**To:** Andrew MacNichol , Community Development Director  
**From:** Ryan A. Percival, P.E., Town Engineer  
**CC:** Mary Benedetto, Senior Planner  
**Date:** July 6, 2023  
**Re:** Grandview Road Extension

**PLAN SET:**  
MAJOR SITE PLAN MODIFICATION  
GRANDVIEW ROAD SUBDIVISION - PRIVATE WAY  
(GRANDVIEW ROAD EXTENSION)

We have reviewed the comments provided by the CPDC and Engineering Division in regards to the the Major Modification of a Definitive Subdivision known as Grandview Road. Comments and associated responses by Fodera Engineering (FE) follows:

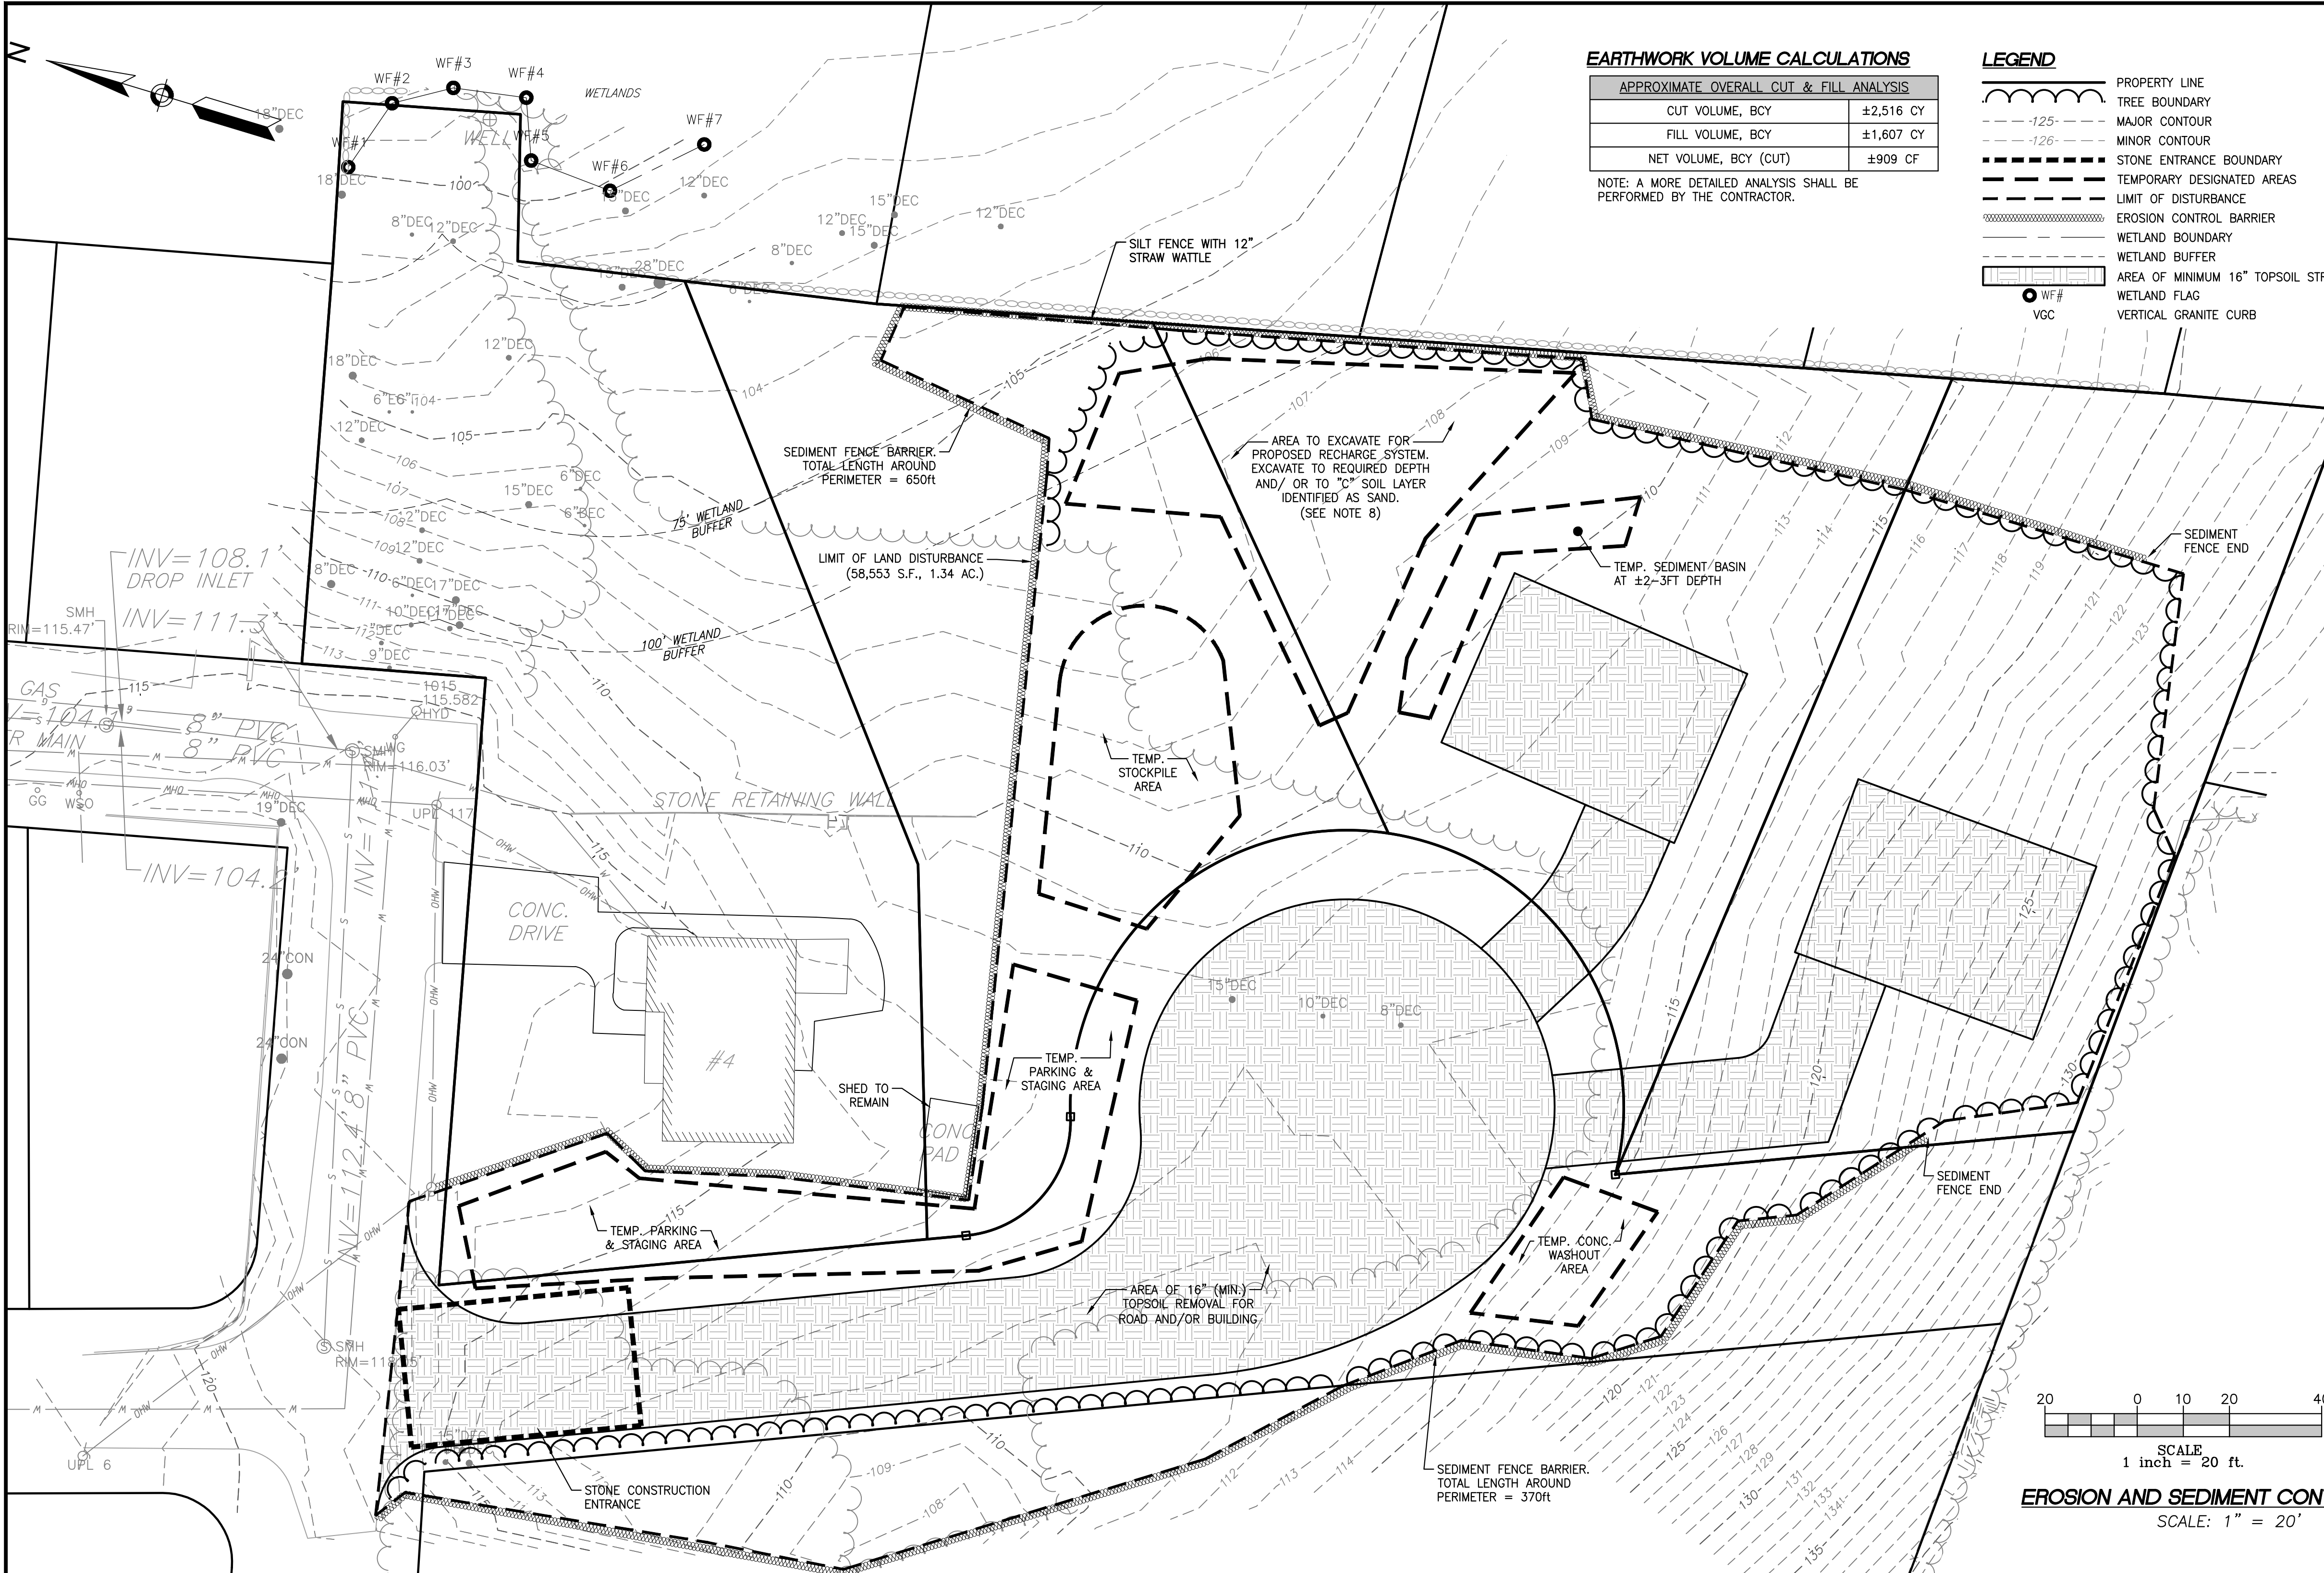
- Lot 4 drainage pipe design so as to not discharge into Lot 3 or the proposed sidewalk.  
*FE Response: Roof runoff pipe from Lot 4 has been revised to enter directly into the drain manhole rather than daylighting to the sidewalk.*

- Rip-rap design location being so near to the property line and ensure DEP requirements are met. Please provide further explanation on all overflow discharging to this area.  
*FE Response: The rip-rap outfall has been removed along with this point of discharge. Previously, the point of discharge was added to control peak rate of runoff and have it reduced compared to existing conditions. Although having the point of discharge and rip-rap outfall was satisfactory with it in place, we further determined that it was not needed in this case. The detention pond's overflow weir is satisfactory alone. Peak*

**JOB NO.:** 20160-149  
**SHEET TITLE:**  
 UTILITY + ROADWAY PROFILE PLAN  
**SHEET NUMBER:**  
 C-5

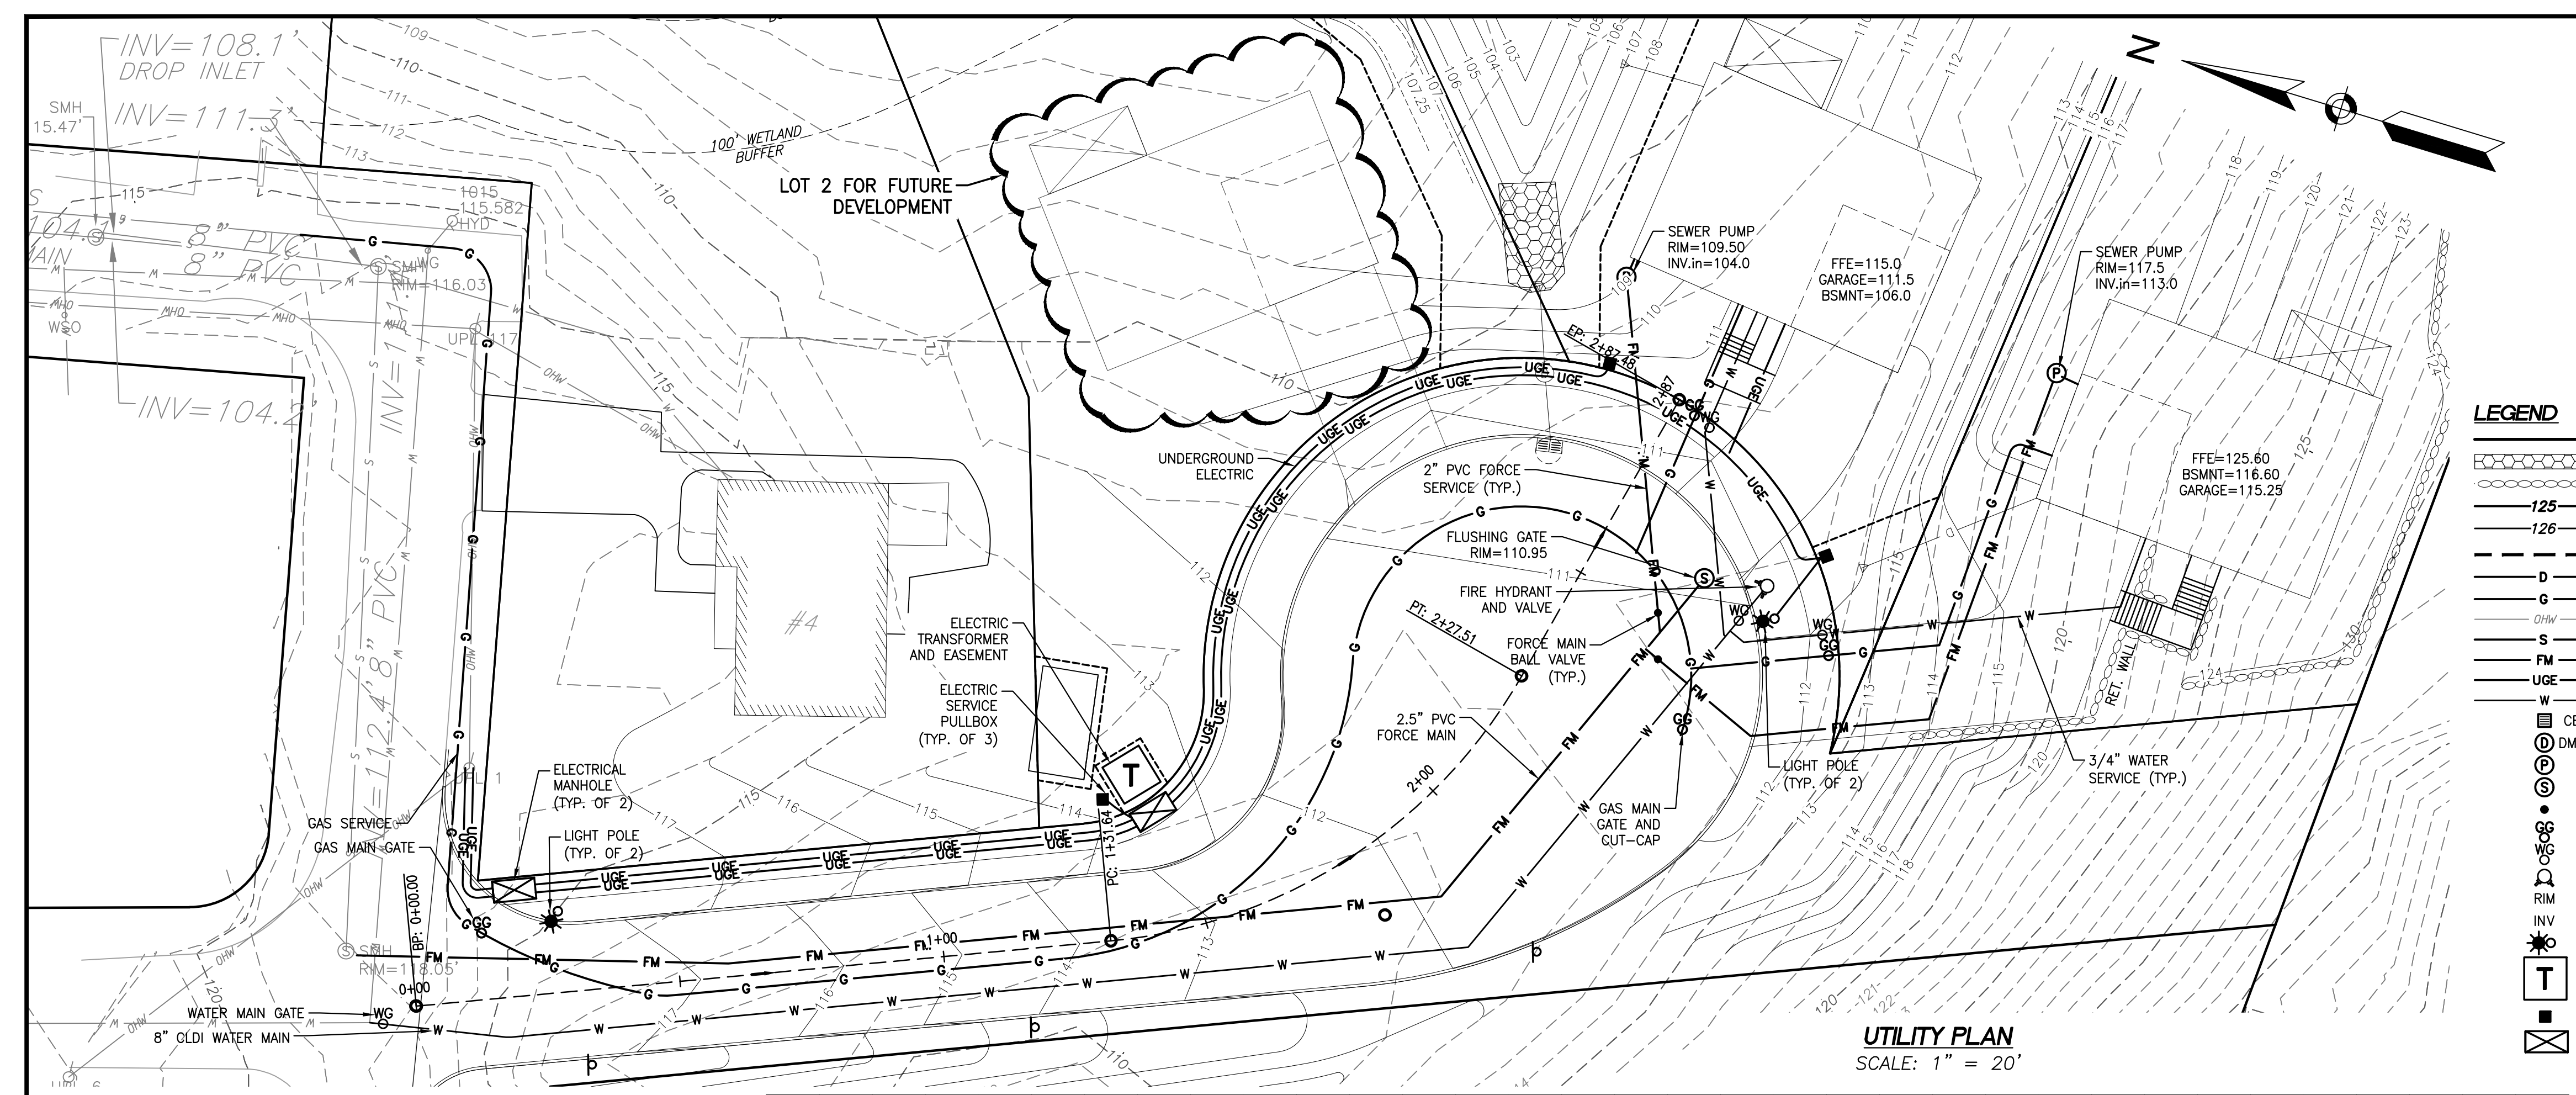
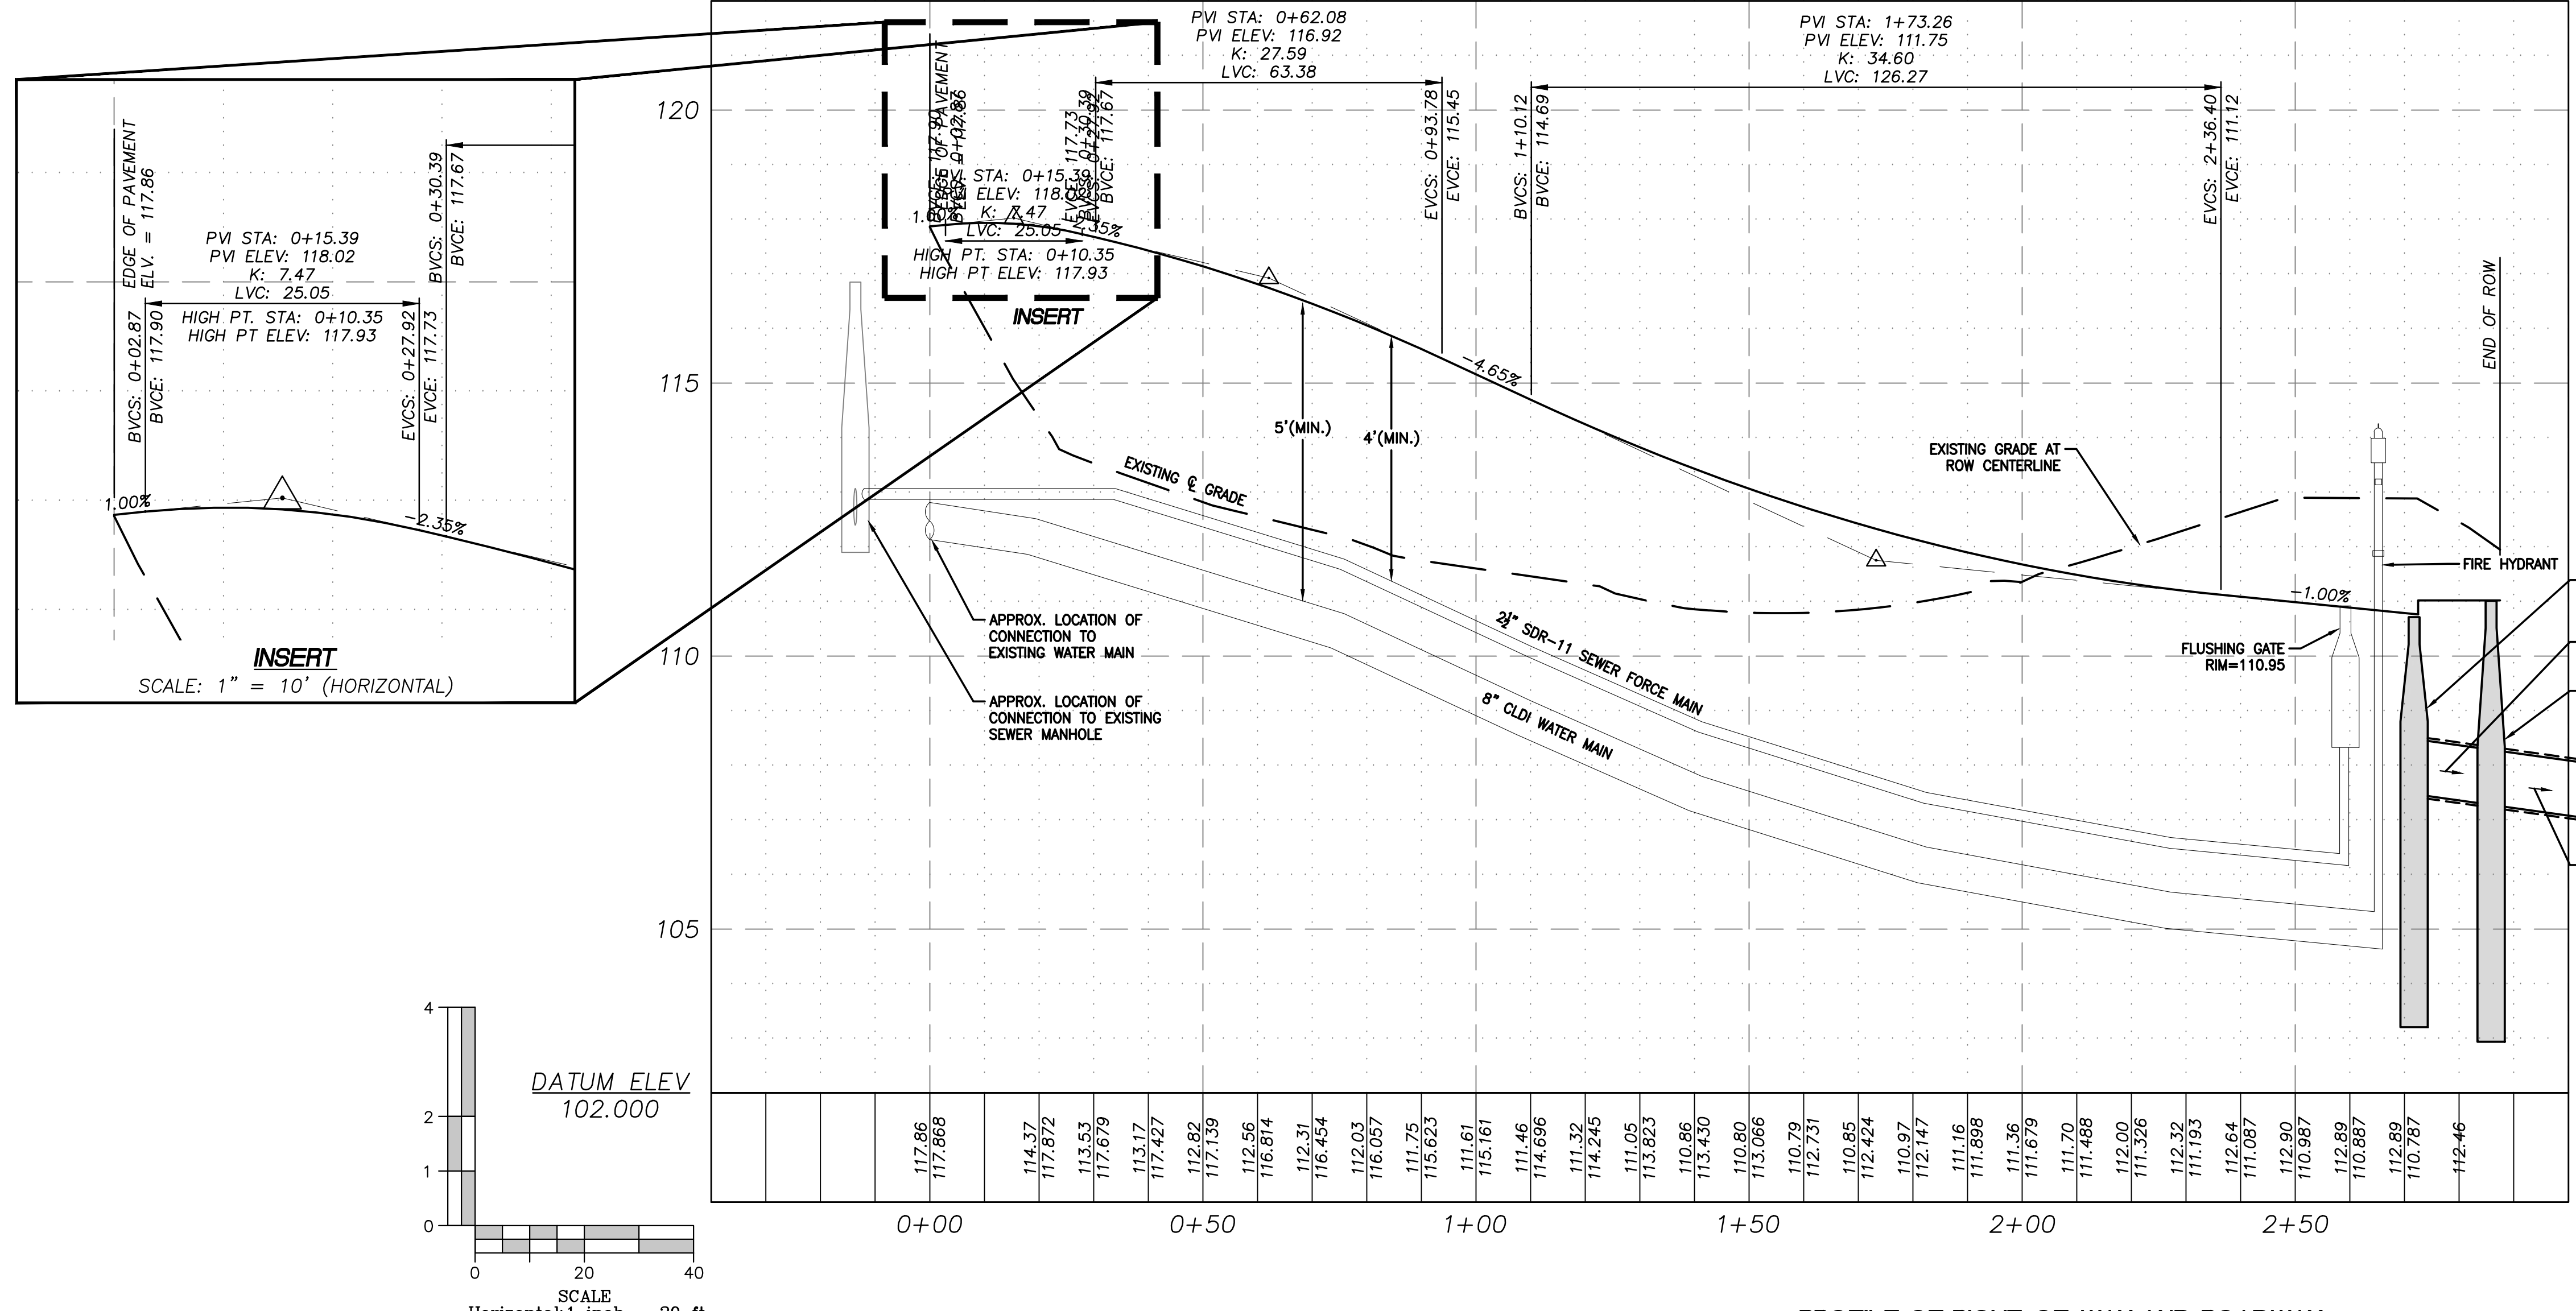
- Inverts of the existing sewer manhole should be provided, as well as a detail for the force main connection.  
***FE Response: Invert of the existing sewer manhole was provided by the surveyor and is INV=112.4. Details associated with the force main are on sheet C-6.***
